## Product Change Notification / NTDO-04TZHM142

CCB 4883 Final Notice: Qualification of CEL-8240 as a new mold compound for 2N700x, DNx5xxN3, LP0701N3, TxxxxxN3, VNxxxxxx and VPxxxxxx device families available in 3L TO-92 package assembled at CRTK assembly site.

**CCB 4883**  
**Pre and Post Change Summary**  
**PCN #: NTDO-04TZHM142**

## **QUALIFICATION REPORT SUMMARY**

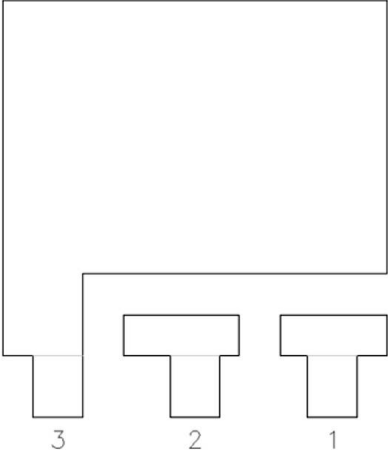
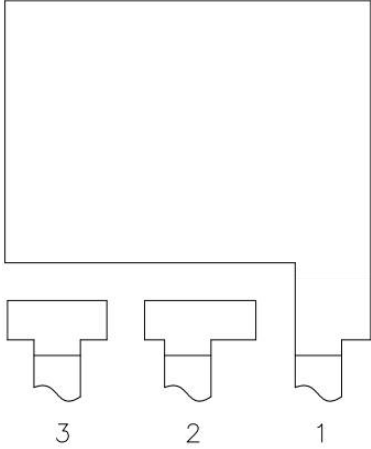
**Description of Change:**Qualification of CEL-8240 as a new mold compound for 2N700x, DNx5xxN3, LP0701N3, TxxxxxN3, VNxxxxxx and VPxxxxxx device families available in 3L TO-92 package assembled at CRTK assembly site.

# Package Layout

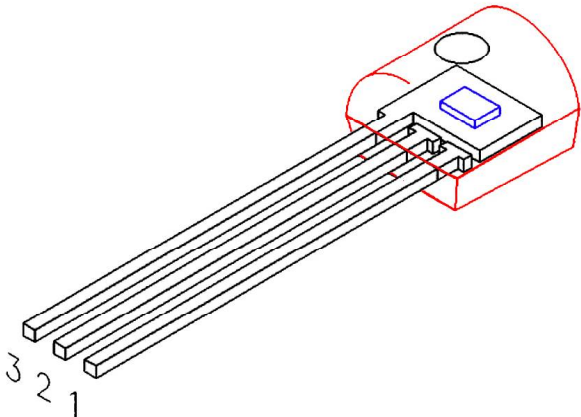
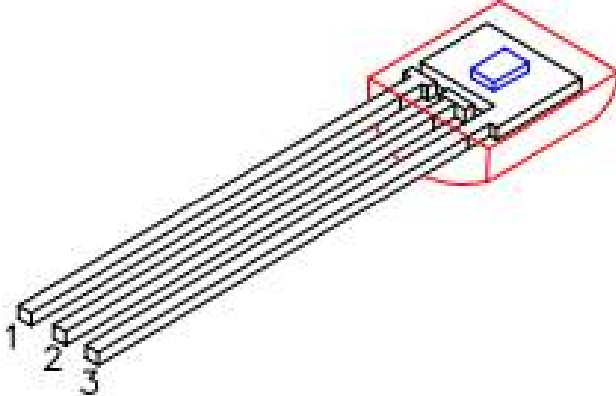
GTK	CRTK
 <p>The diagram shows a GTK package layout. A blue die is mounted on a substrate. Three leads are shown extending from the package, labeled 3, 2, and 1 from left to right. A red wireframe indicates the package's shape.</p>	 <p>The diagram shows a CRTK package layout. A blue die is mounted on a substrate. Three leads are shown extending from the package, labeled 1, 2, and 3 from left to right. A red wireframe indicates the package's shape. Below the diagram, the text "Die sit on flat side" is present.</p>
